# Access Compliance Report

## Public Rights-of-Way

### (Curb Ramps)

Intersection ID: 16944	Main Street: N_SHARON_AMITY_RD	Cross Street: MONTAGUE_ST	Location: NW
ADA ID: 6913277451F1	Ramp Type: PerpDiag	Initial Pass/Fail: Fail	Overall Compliance: No
			Severity Score: 33.75

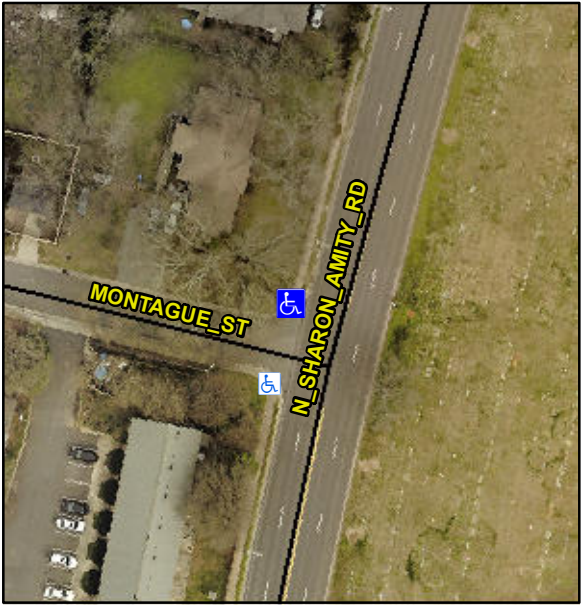
Codes/Mitigation Info/Possible Solution		Field Measurements/Component Compliance					
	Possible Solutions:						
	Remove & Replace Curb Ramp With Two New Directional Ramps or Equivalent.	N/A	Ramp Length (in)	58.0	Yes	Ramp Slope (%)	5.9
		No	Ramp Width (in)	37.0	No	Ramp XSlope (%)	14.9
		N/A	Flare Type LT	N/A	N/A	Flare Type RT	N/A
		N/A	Flare Slope LT (%)	N/A	N/A	Flare Slope RT (%)	N/A
		N/A	Flare Traversable LT?	N/A	N/A	Flare Traversable RT?	N/A
		N/A	Landing Length (in)	N/A	N/A	DWS Provided?	N/A
		N/A	Landing Width (in)	N/A	N/A	DWS Contrast?	N/A
		N/A	Landing Slope (%)	N/A	N/A	DWS Length (in)	N/A
		N/A	Landing X Slope (%)	N/A	N/A	DWS Full Width?	N/A
		N/A	Landing Curb? (Y/N)	N/A	N/A	DWS Offset (in)	N/A
		N/A	Shared Landing?	N/A			
		N/A	Gutter Ponding?	N/A	N/A	Gutter Slope (%)	N/A
		N/A	Gutter Lip Ht (in)	N/A	N/A	Gutter X Slope (%)	N/A
		N/A	Painted X Walk1?	No	N/A	Painted X Walk2?	No
			X Walk 1 Direction	To S		X Walk 2 Direction	To E

N/A	X Walk 1 Width (in)	N/A	N/A	X Walk 2 Width (in)	N/A
			X Walk 1 Slope (%)	0.2		X Walk 2 Slope (%)	3.5
			X Walk 1 X Slope (%)	6.2		X Walk 2 X Slope (%)	0.1
		N/A	Ramp inside XWalk1?	N/A	N/A	Ramp inside XWalk2?	N/A
<p>Surveyor Notes:</p> <p>N/A</p>			Road Slope (%)	2.9	N/A	Clear Space?	N/A
			Road X Slope (%)	9.7	N/A	Clear Space to XWalk (in)	N/A
<p>PROW/ADA:</p> <p>R304.5.1, R304.5.3</p>		N/A	Any Obstructions?	N/A	N/A	Storm Grate/Utility Hazard?	N/A
			Obstruction Type			Storm Grate/Utility Type	
Total Cost:		\$	3200.00		N/A		N/A
					Yes	Surface Condition? (G/P)	Good
